SERVICE BULLETIN

SERVICE BULLETIN INDEX

FIGURE 3
BLANKING CONNECTOR ASSEMBLY INSTALLATION

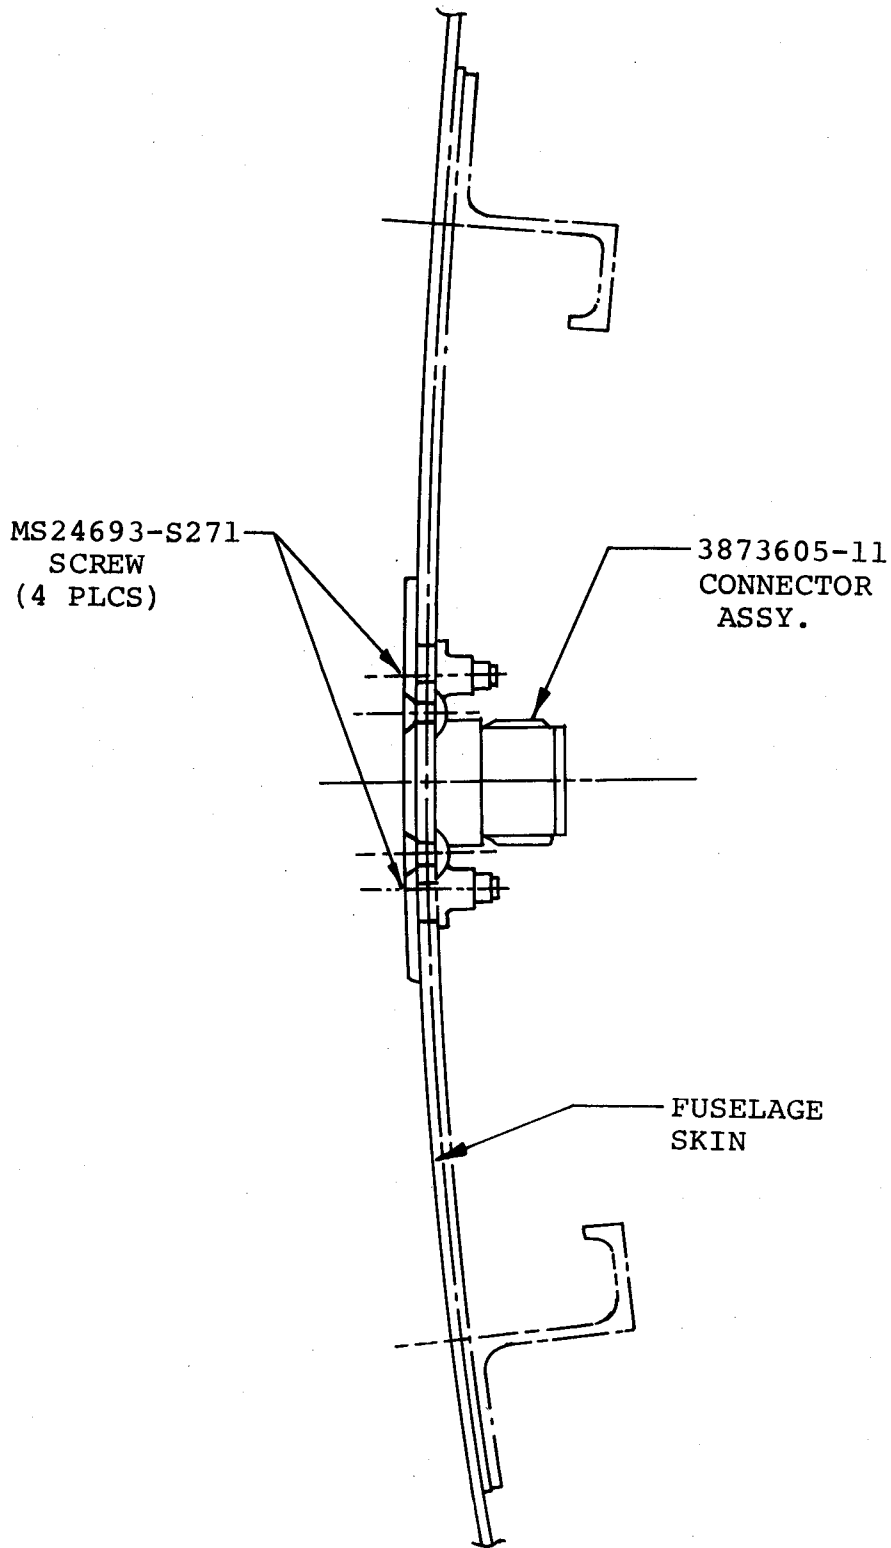
1. Disconnect coaxial antenna lead.
2. Remove existing flight telephone antenna.
3. Install blanking plate connector assembly P/N 3873605-11 using 4 ea. screws MS24693-S271. Apply PRL422B as required. Ref. Figure 3.
4. Connect the existing coaxial antenna lead to the blanking plate dummy connector and secure lead as required.

FIGURE 1: VIEW LOOKING INBD., L/H PYLON

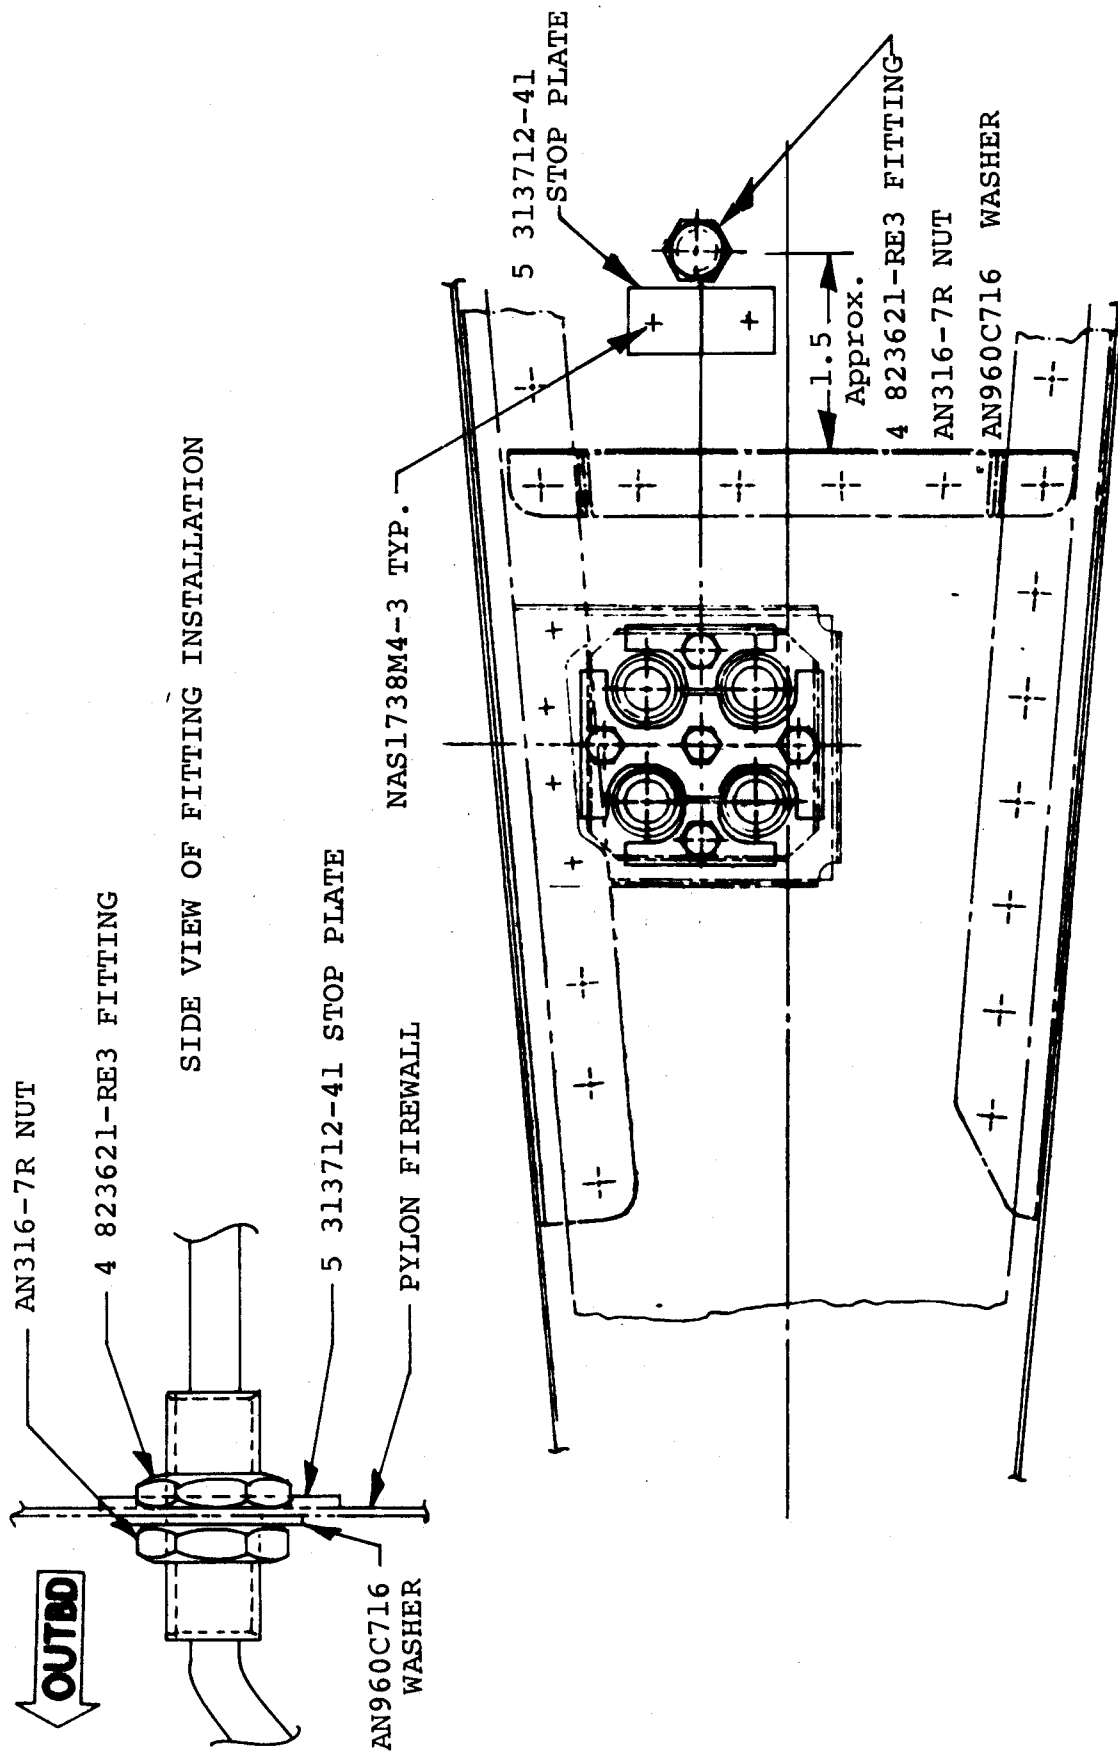
- A. Remove electrical power from the aircraft.
- B. Remove the forward-most access panel on the bottom of the right hand pylon fairing. Remove upper engine cowling.
- C. Drill a 15/32 in. hole through the pylon skin and install one each P/N 4 823621-RE3 fitting, AN960C716 washer, AN316-7R nut, 5 313712-41 stop-plate, per Figure 1. Avoid damaging generator leads.
- D. Disconnect wires 2P16B16 and 2P17B16 from right hand starter/generator terminals A and D. Cap and stow.

FIGURE 1

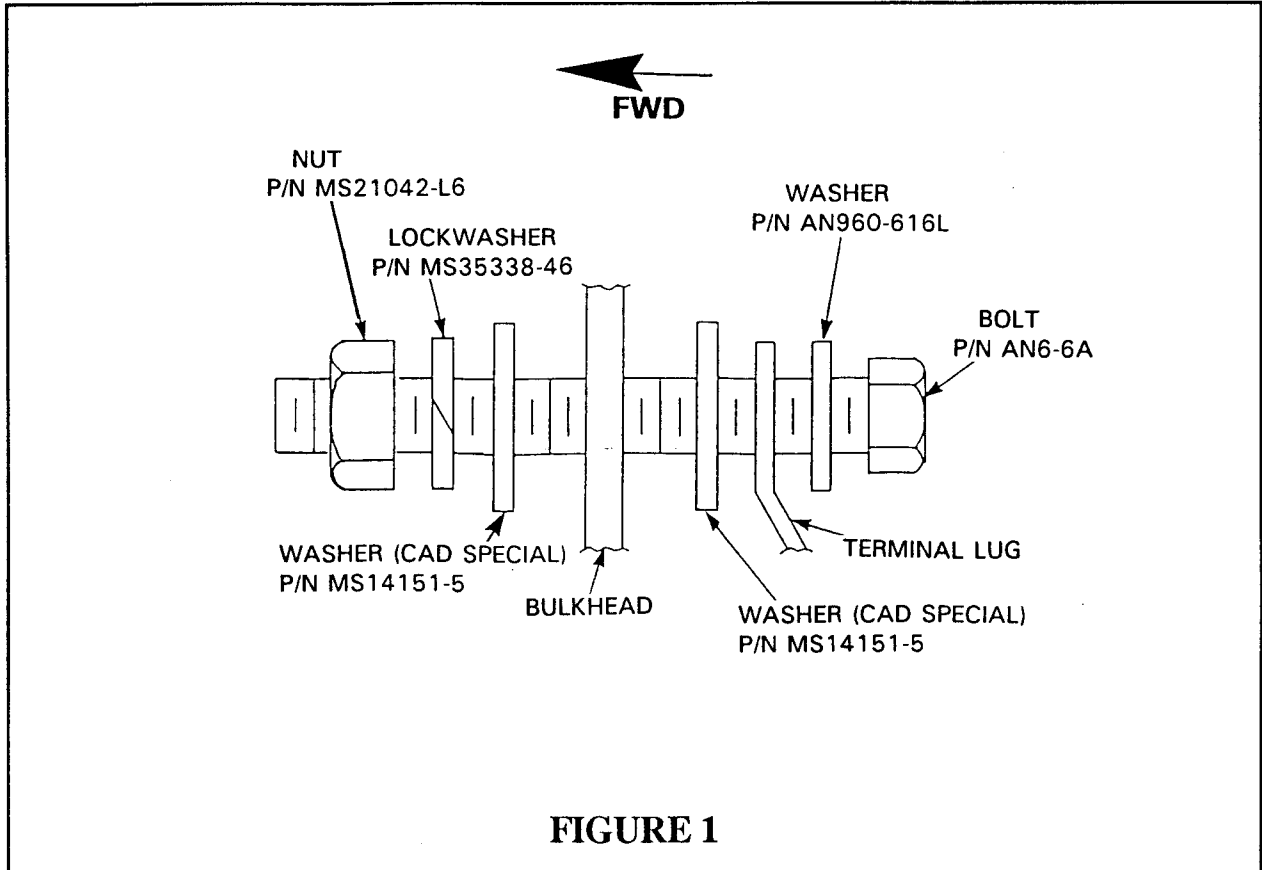
- H. Assemble grounds using new hardware. Head of bolt on aft side of extrusion. Refer to Figure 1.

FIGURE 2

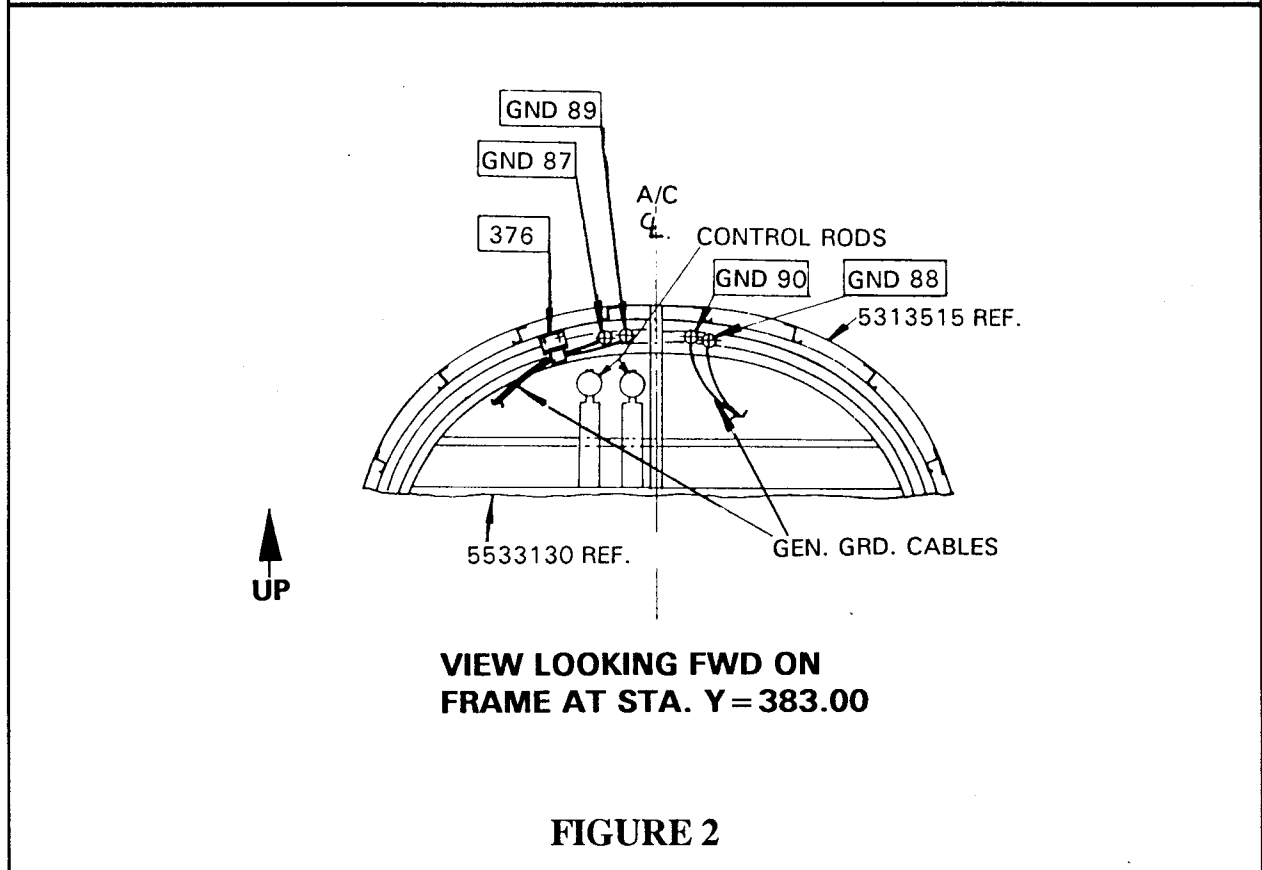
- (1) 38 GND - #2 battery ground return (Sta. 340 RHS)
 - (2) 39 GND - #1 battery ground return (Sta. 340 LHS)
 - (3) 87 GND, 88 GND, 89 GND and 90 GND - #1 and #2 generator ground returns (Sta. 383 overhead, left and right of aircraft centerline) on aft wall of forward baggage compartment. Refer to Figure 2.

FIGURE 3

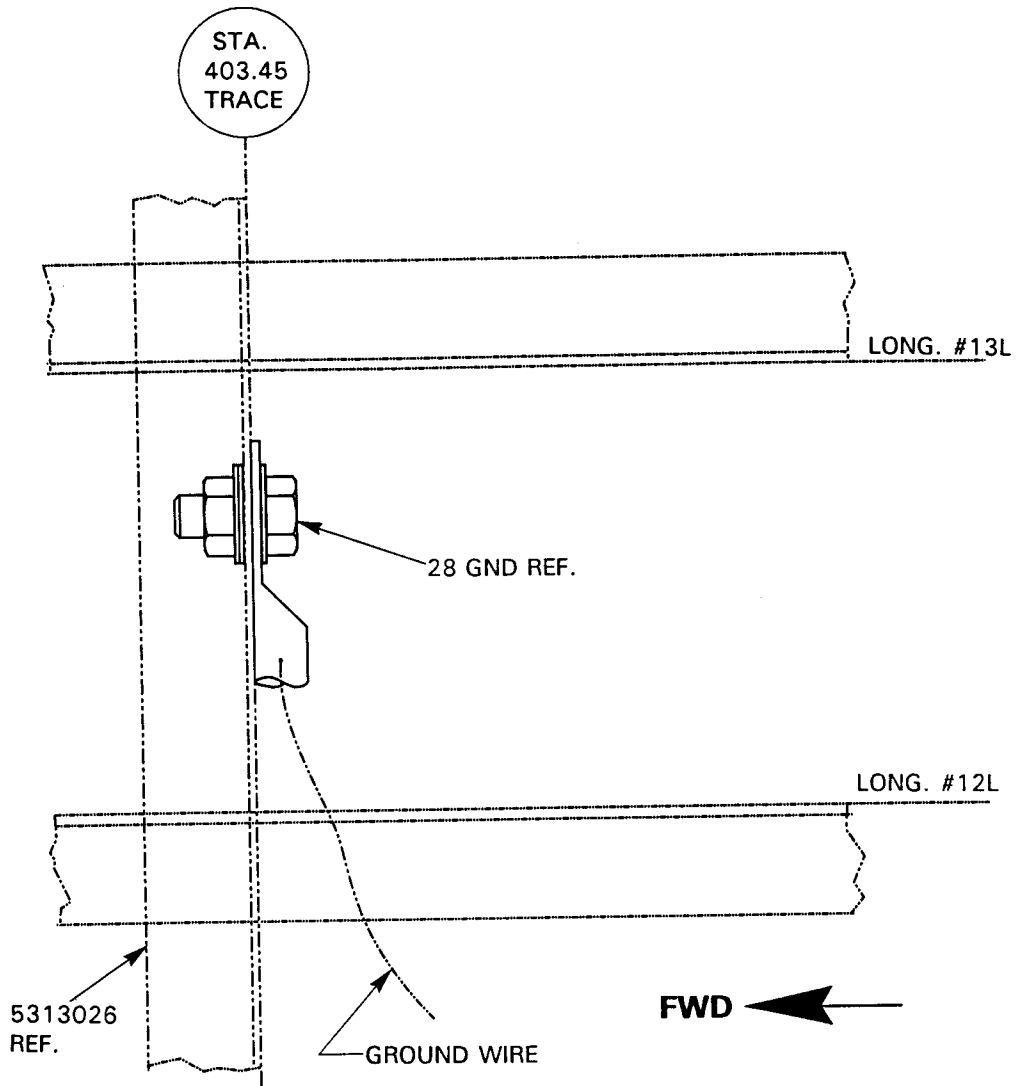
- E. For 28 GND only; enlarge hole in structure (Frame 403.45) and in terminal lug 28 GND to 0.385-.400 inches if required. Refer to Figure 3
- F. Remove all paint and primer from both sides of all terminal lugs and mating area structure.

FIGURE 1

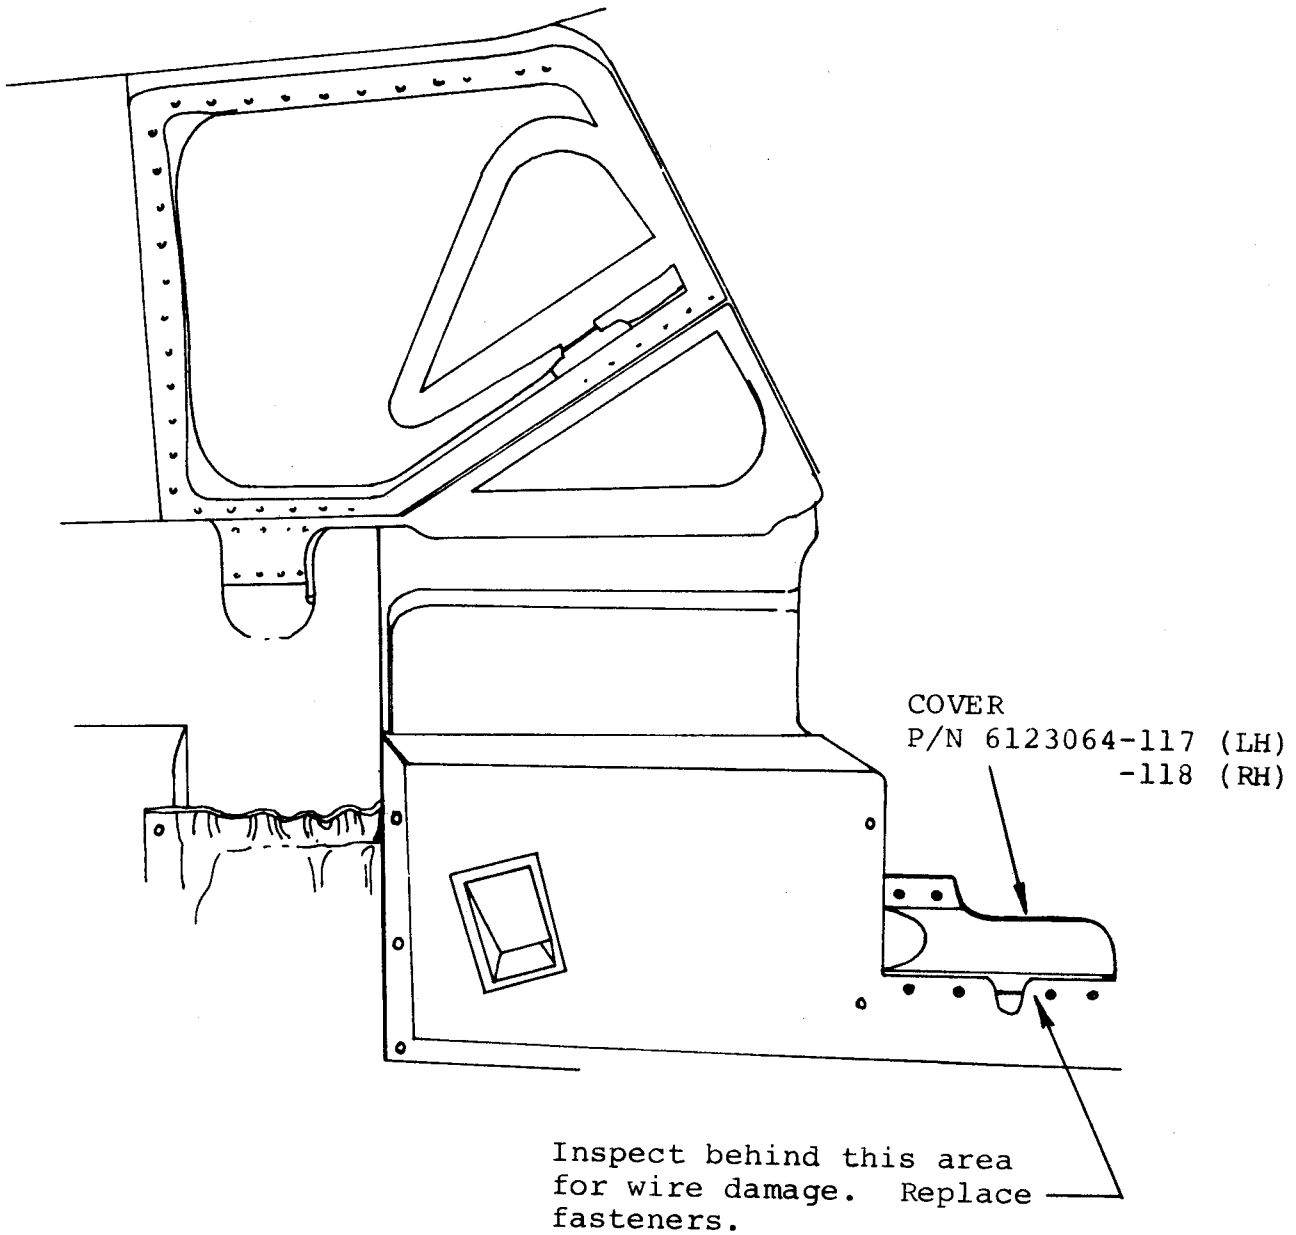
- A. Turn off battery and electrical master switches and assure that external power is not applied to the aircraft.
- B. Remove the lower forward left and right hand panels. See Figure 1.
- C. Inspect the cable bundles in the area immediately behind the lower forward mounting screw on both LH and RH covers for wire damage. Should damage or chafing be noted, repair wires as necessary.

- D. To prevent further damage, wrap the affected area with PVC-80 or equivalent chafe-guard and secure with tie-wraps.
- E. Remove the existing tinnerman type nut-plates from the lower forward positions on each cover and replace them with new nut-plates NAS1474A08. The new nut-plates may be located and riveted in place with MS20426AD3-4 rivets.
- F. Reinstall the left and right covers using washer NAS391-8P and screw MS24693-S48.

FIGURE 1

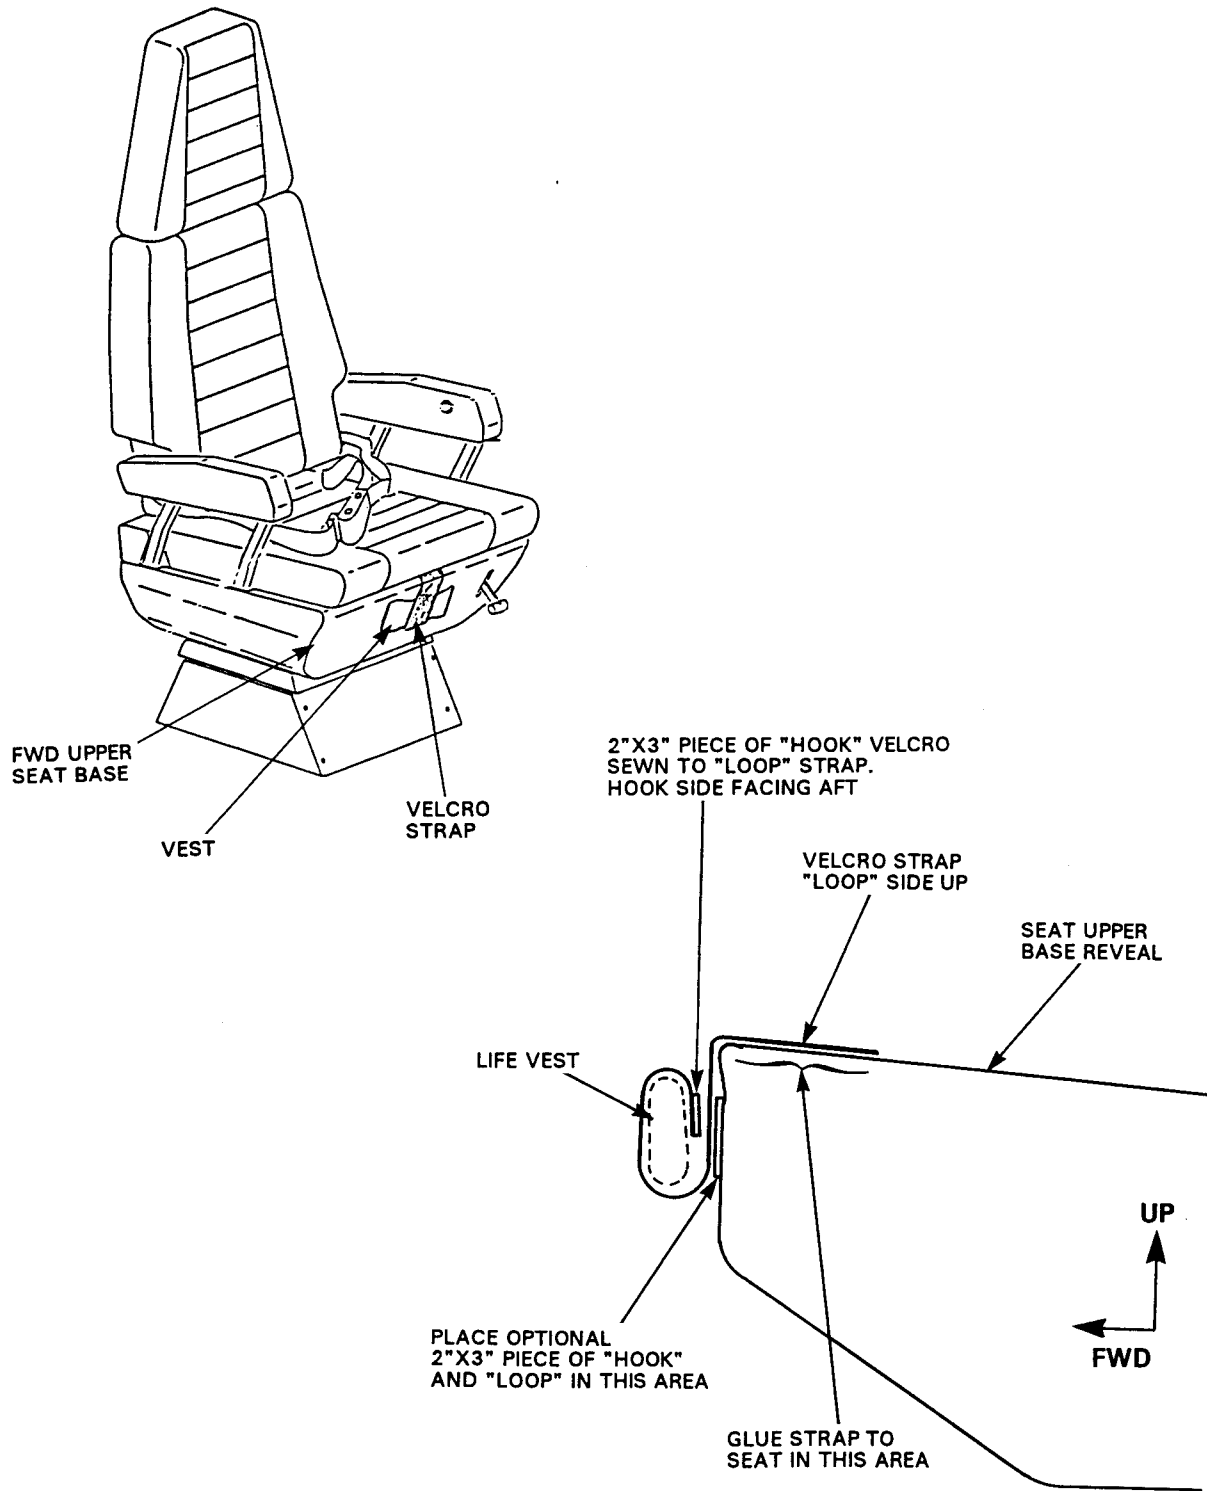
- E. Place life vest with strap assembly in front of seat cushion upper base and allow life vest to hang from velcro strap. Refer to Figure 1.
- F. When desired location is achieved, cut velcro "Loop" strap to appropriate length.

- G. Secure backing side of "Loop" strap to seat cushion support with 3M Scotch Grip P/N 3M 1300L. Refer to Figure 1.
- H. Perform same installation sequence with remaining cabin seats.
